Landscape Review Committee
ZOOM Online Meeting
Wednesday, September 15, 2021 - 12:00 – 1:00 PM

DATE: September 15, 2021
TO: Landscape Review Committee Members
FROM: Amy Dixon, Contract Planner
SUBJECT: Landscape Plan Review Application (L 13-21)

DATE: September 15, 2021
TO: Landscape Review Committee Members
FROM: Amy Dixon, Contract Planner
SUBJECT: Landscape Plan Review Application (L 14-21)

DECISION, CONDITIONS, FINDINGS OF FACT AND CONCLUSIONARY FINDINGS FOR THE APPROVAL OF A LANDSCAPE PLAN REVIEW FOR A NEW INDUSTRIAL DEVELOPMENT AT 631 NE 1st STREET

Figure 2: Berkey Estates Street Tree Plan

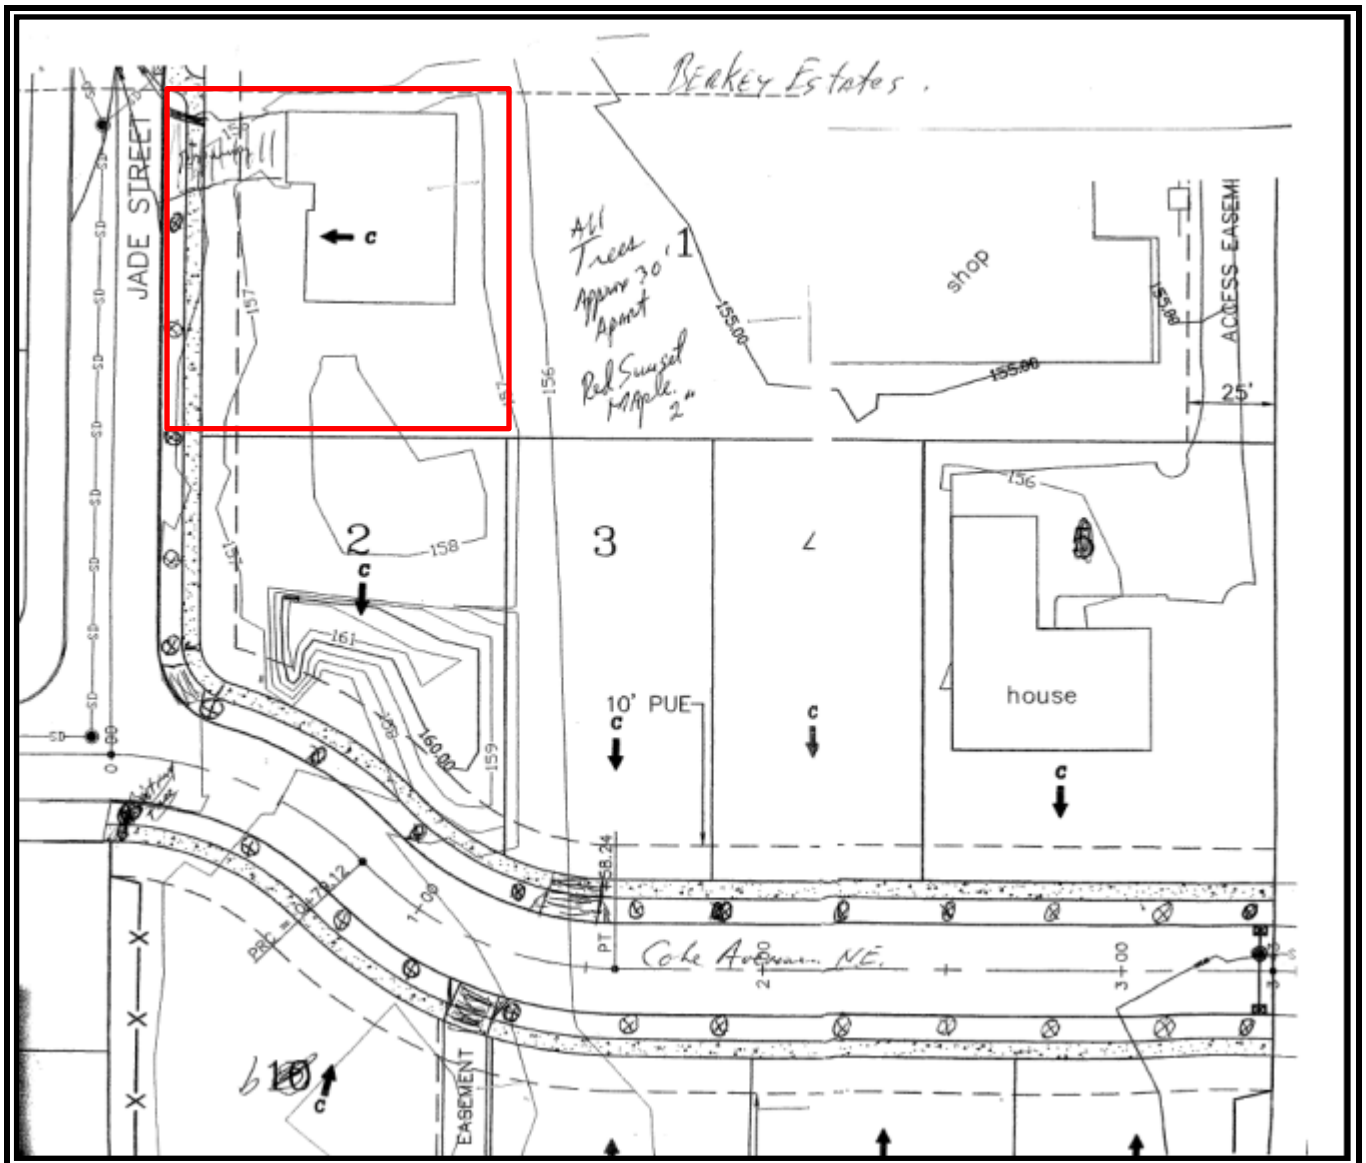
FINDING: SATISFIED WITH CONDITION OF APPROVAL #1. There is an approved street tree plan for the subdivision on file with the Planning Department. The approved plan indicates all trees are to be a minimum 2-inch red sunset maple tree.

CONDITION FOR FINDING: That one (1) replacement street tree be planted in the NE Jade Street planter strip in approximately the same location as the existing. The tree shall be a red sunset maple tree having a minimum 2-inch caliber at planting.

Proposed Landscaping along North Property Line & Parking Lot

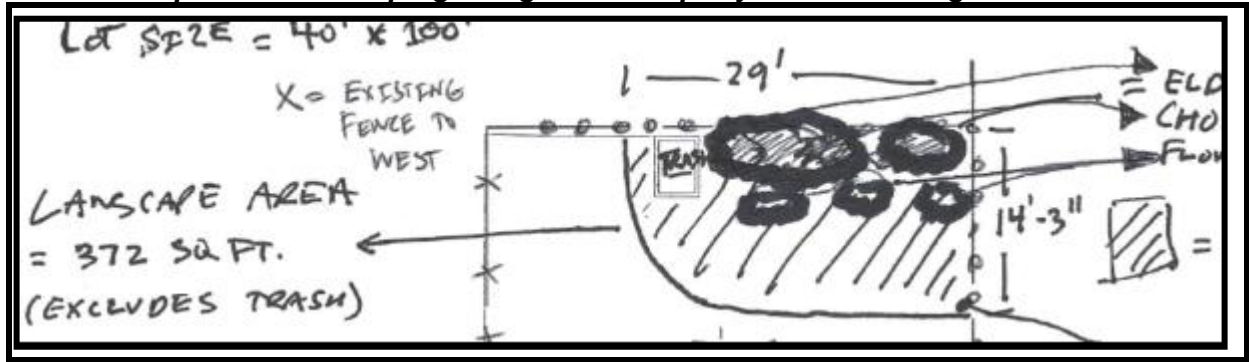
There is one planting area of approximately 375 square feet in size with some tree like shrubs and groundcover proposed. It would seem that a tree would be appropriate in this area to shade the parking lot to reduce heat and to buffer the use from the adjacent property. Therefore, it is necessary to ensure that a tree is installed and is an approved tree listed in McMinnville Street Tree List.

Proposed Landscaping along West Property Line

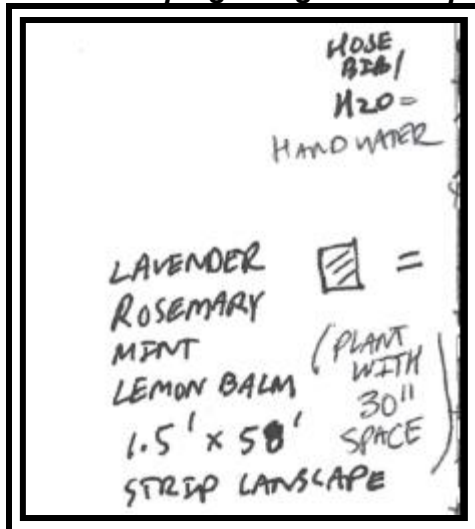
Along the west property line, the proposed site plan indicates low growing shrubs. No trees are proposed. Due to site restraints, the width of the planting area is extremely narrow and would not accommodate trees. With the existing fence and shrubs, the site is compatible and allows for buffering between the site and surrounding properties.

Proposed Landscaping along East Property Line

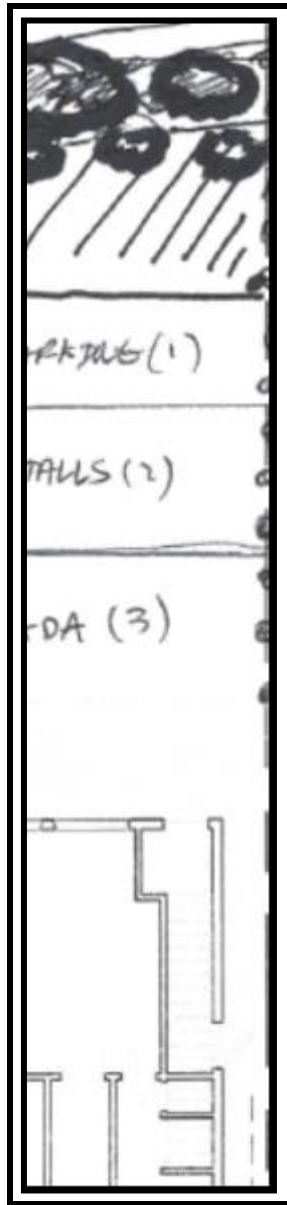
On the eastern property line, the applicant is proposing a fence from the corner to approximately the building. Again, due to the extreme site restraints, there is only space available for a fence. The applicant did mention the adjacent property's landscaping to help with buffering the uses. Although, the property owner does not have any legal rights to require the landscaping to remain. Therefore, using adjacent properties' landscaping a justification is not appropriate.

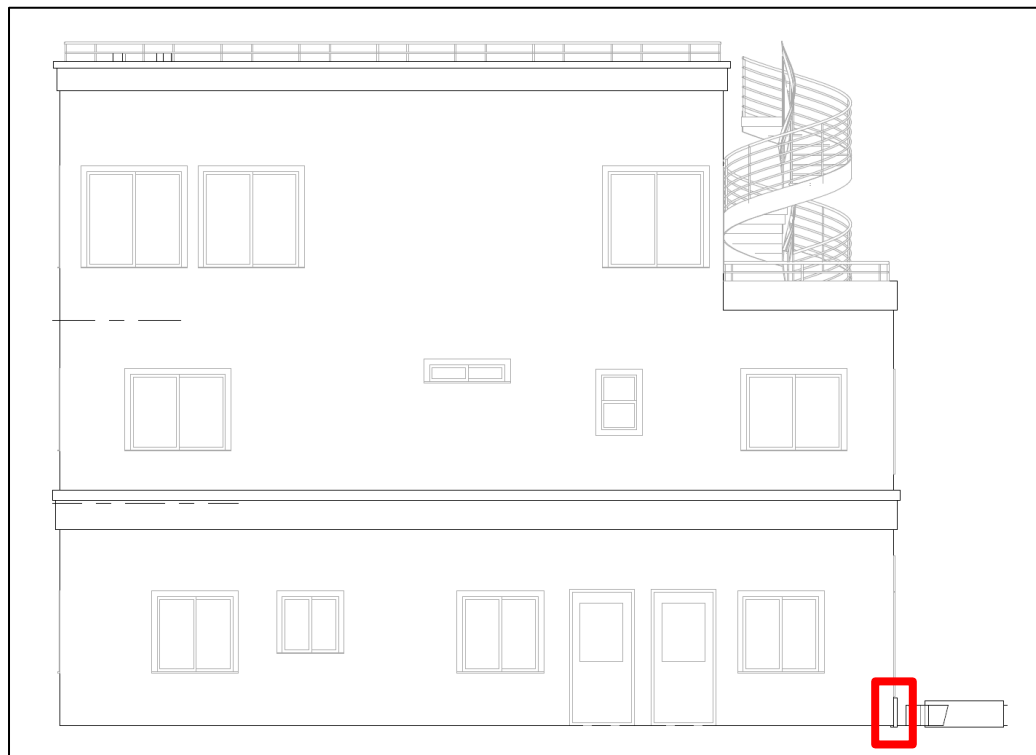
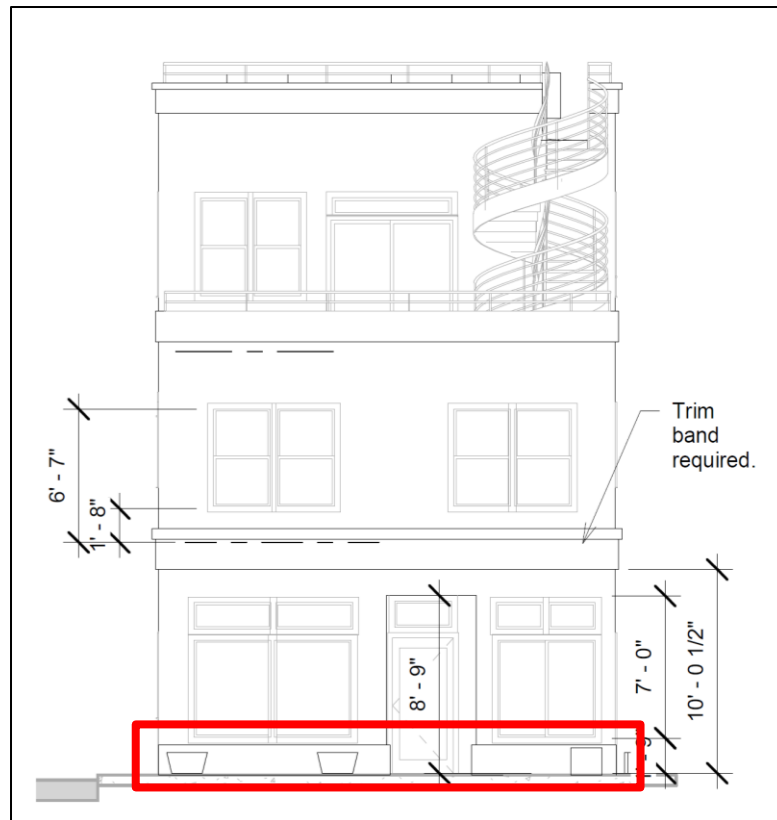
FINDING: SATISFIED. The City concurs with the applicant's findings. The bulkhead feature as identified in the front elevation has a dimensionality that extends outward from the remainder of the building wall. The stucco bulkhead proposed can be seen below:

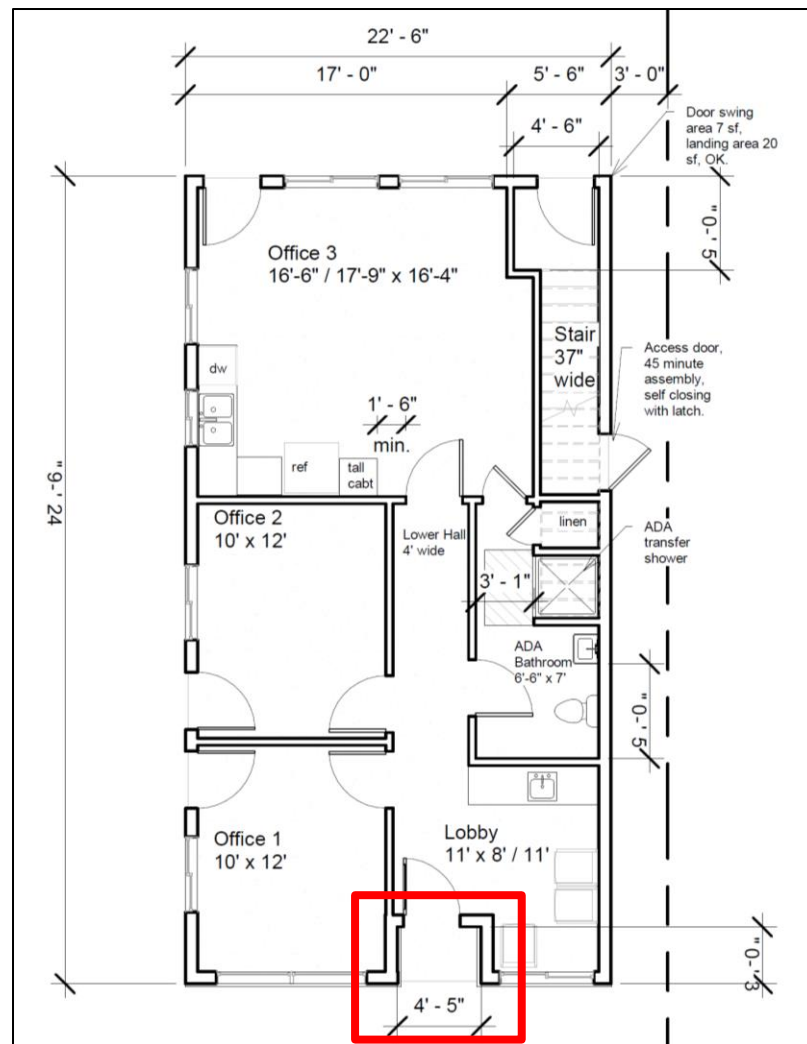
FINDING: SATISFIED. The City concurs with the applicant's findings, but adds that the glazing below the transom line (which is 8' 9" from grade) is approximately 137.83 square feet. Based on the façade width of 22.5', the area below the transom line is approximately 196.875 square feet. Therefore, the amount of glazing below the transom line is just over 70%, and the amount of glazing below the horizontal belt course between the first and second stories (which is at just about 10' in height) is approximately 61%.
